SERVICE BULLETIN

PRODUCT: Computer Monitor
BULLETIN: Monitor 95-005
MODEL: Samtron SC-428PS

SUBJECT: Vertical Deflection Circuit Improvement

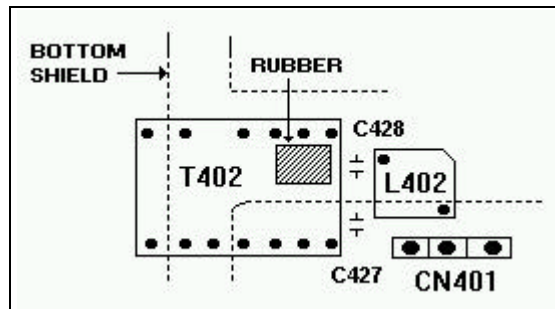
SOLUTION: Add a piece of rubber to insulate the main PCB solder side from the bottom metal shield. See Illustration below showing the section of the PCB where the rubber will be located.

Figure 1

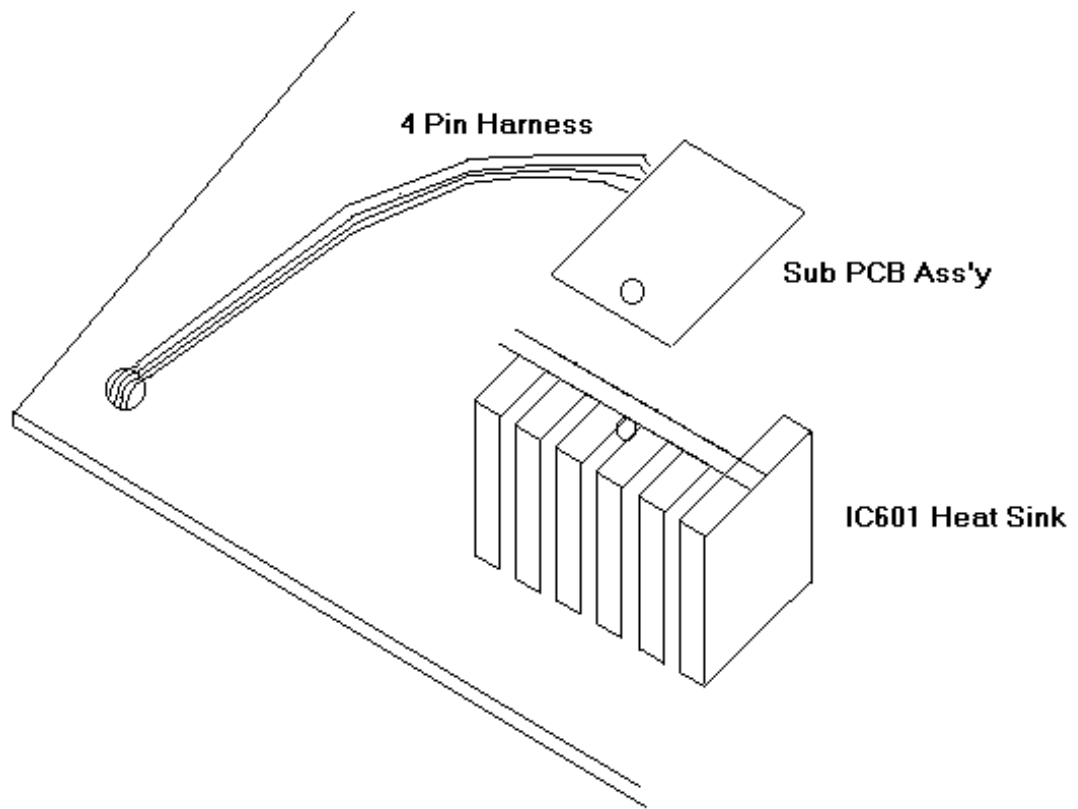
SOLUTION: Add a sub-PCB assembly as in figures 1 and 2 and a snubbing circuit for the horizontal output as in figure 3.
